**FINAL DRAINAGE REPORT
FOR
STERLING RANCH FILING NO. 2**

**September 2020
Project No. 25188.01**

Engineering Review

PCD File No. SF-20-015

DRAINAGE MAP
STERLING RANCH FILING 2
JOB NO. 25188.01
5/15/20
SHEET 1 OF 6

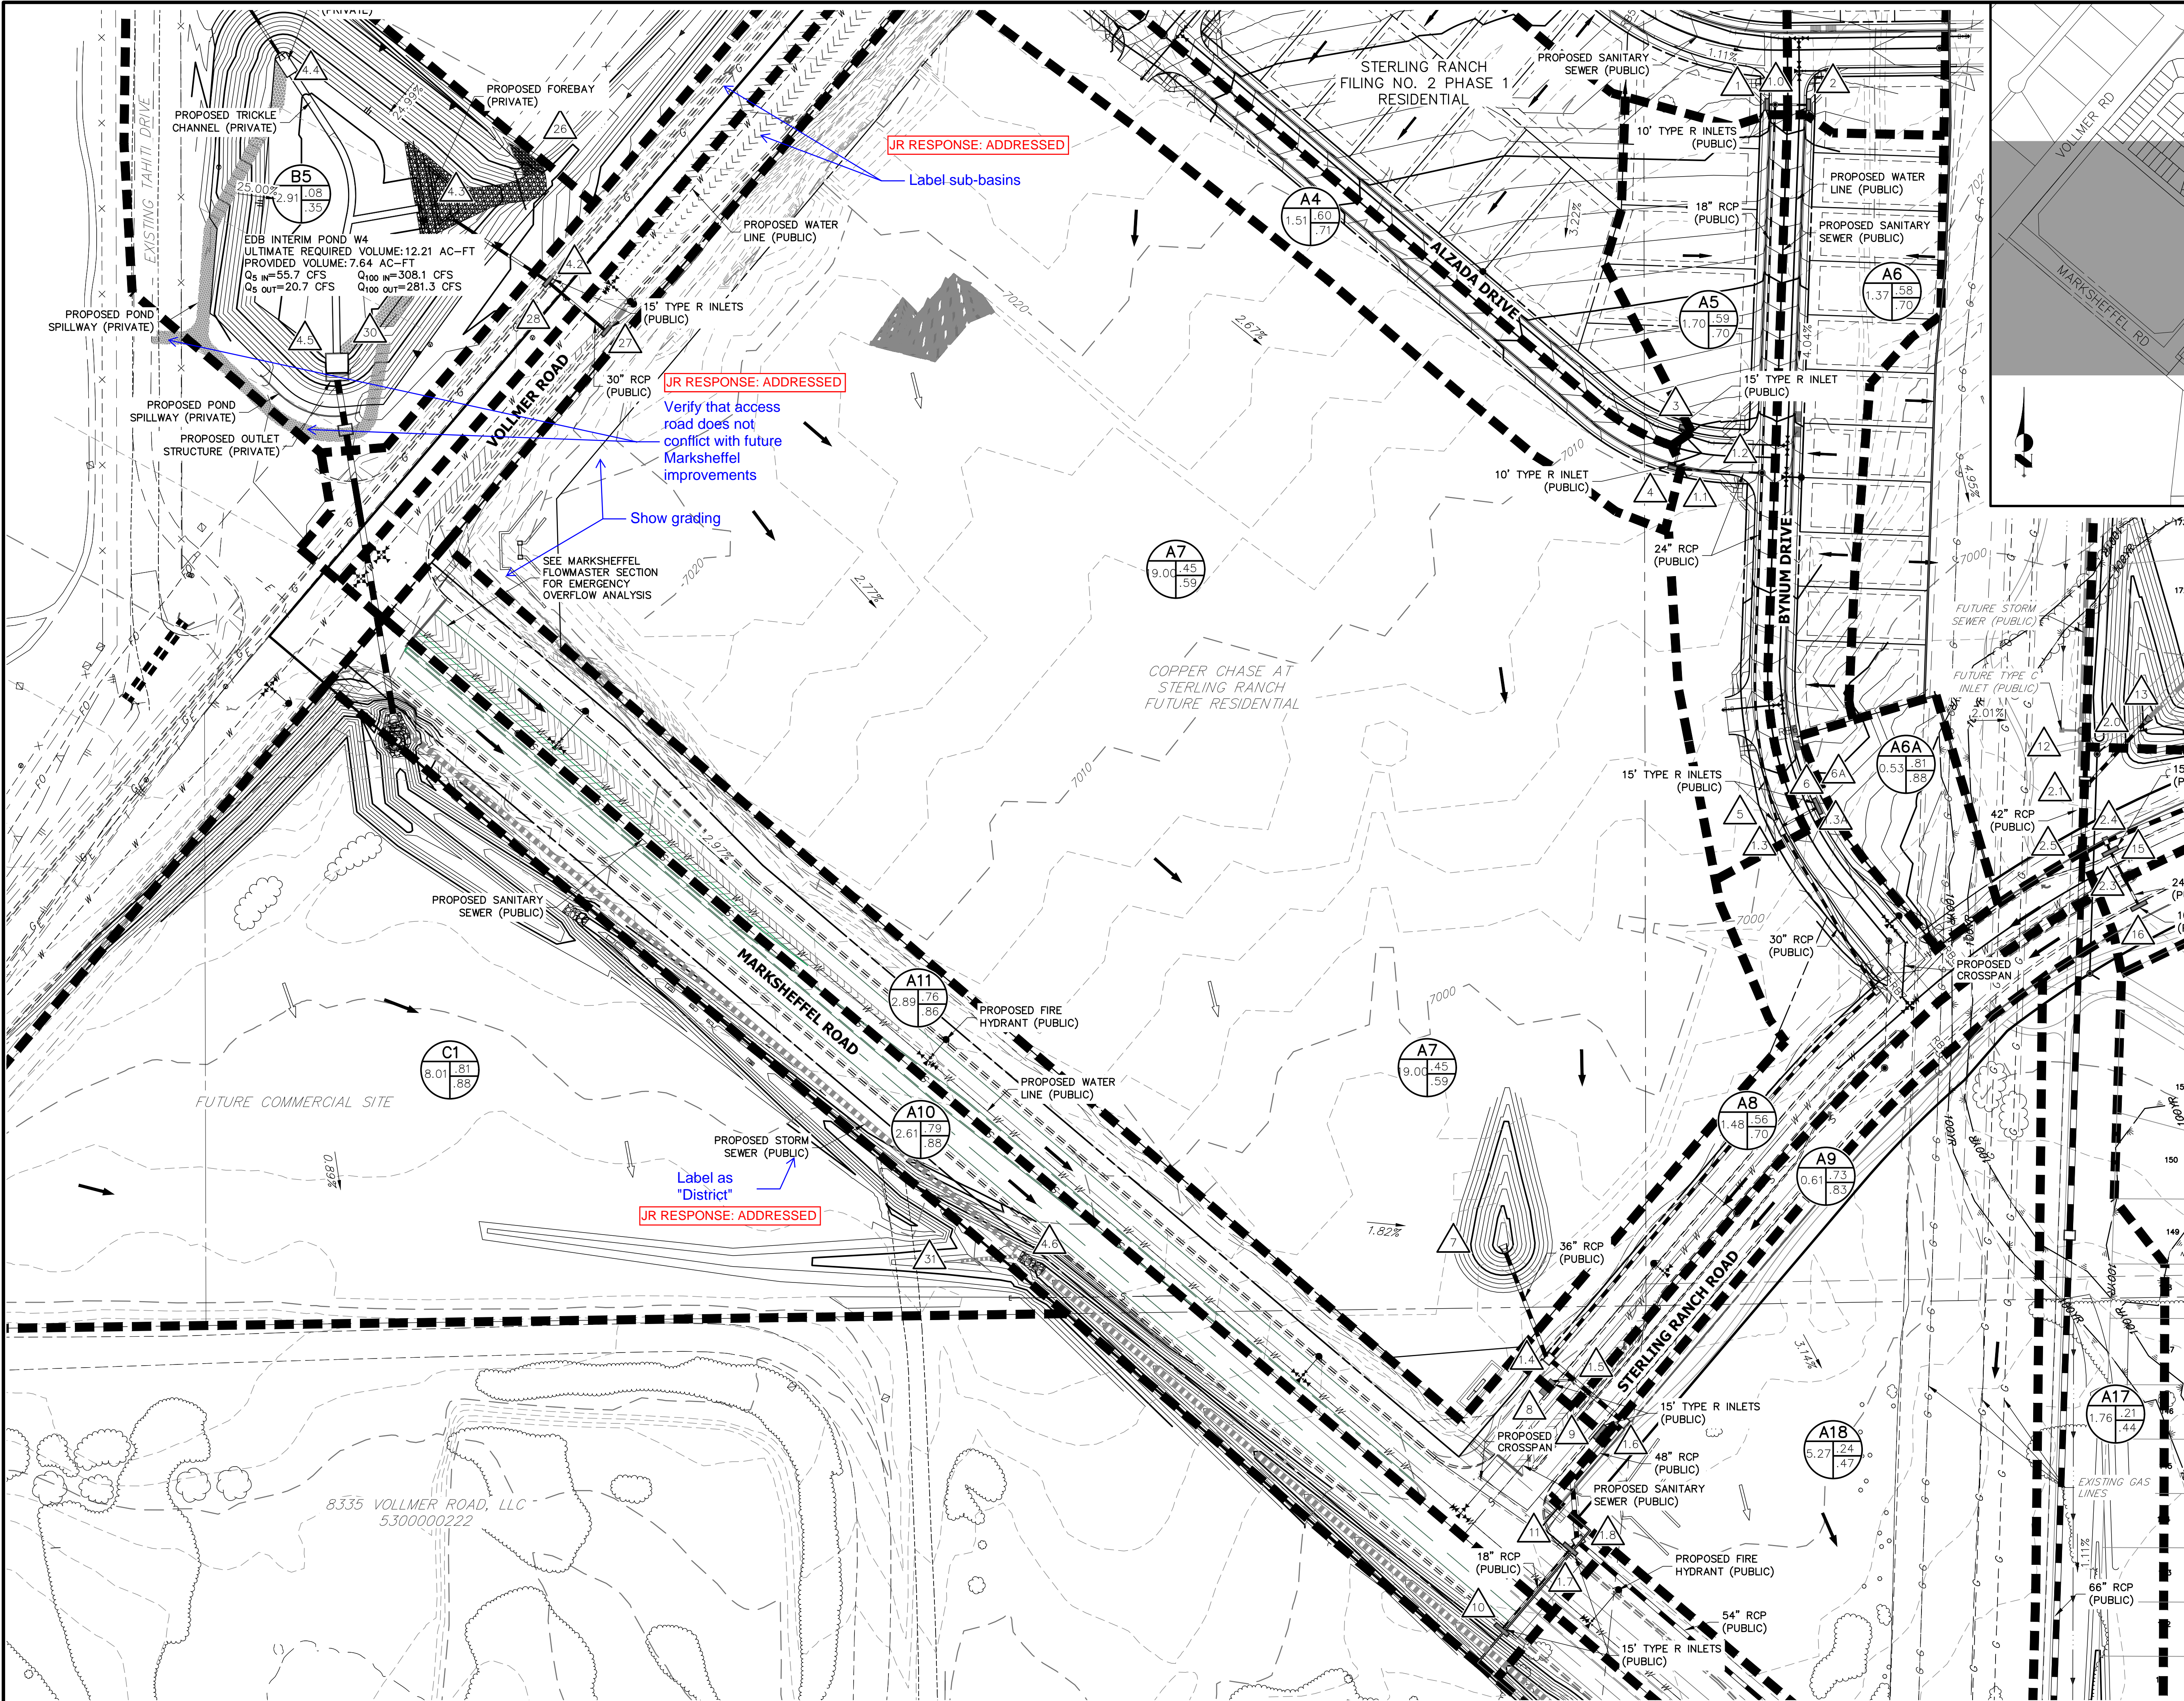
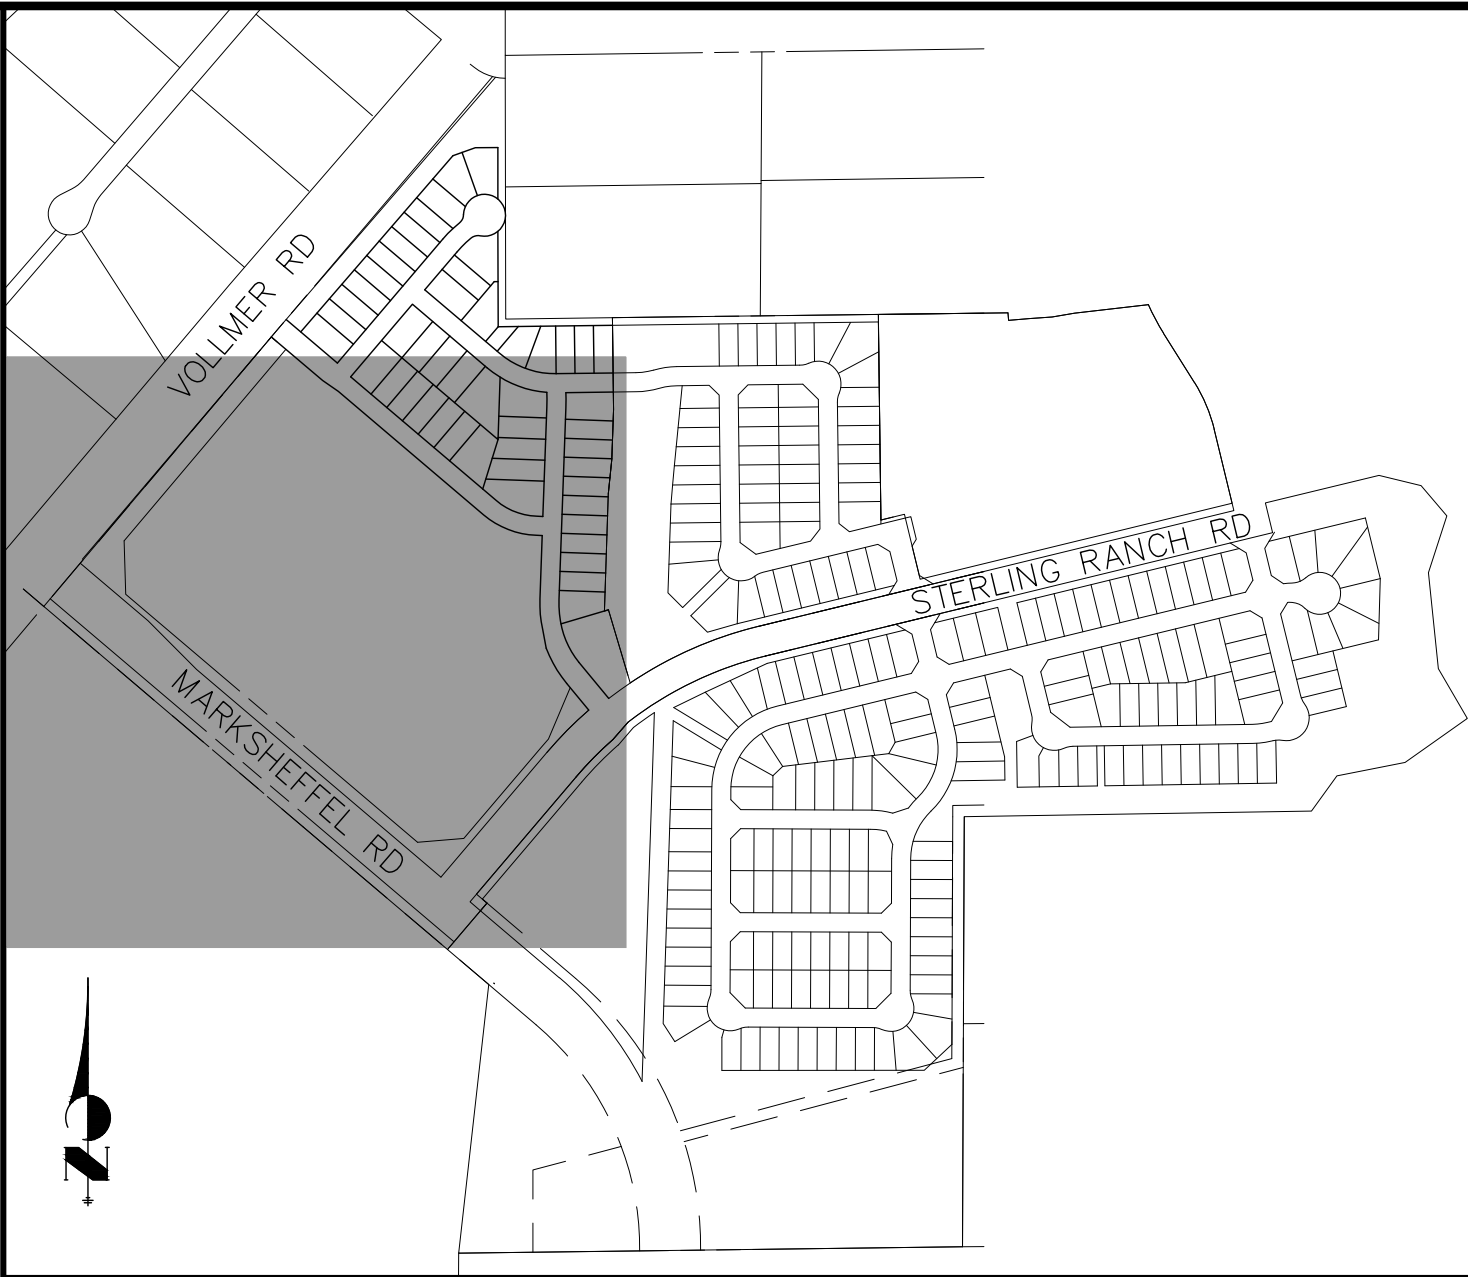
Obtain City approval for maintenance access roads from Marksheffel Road.
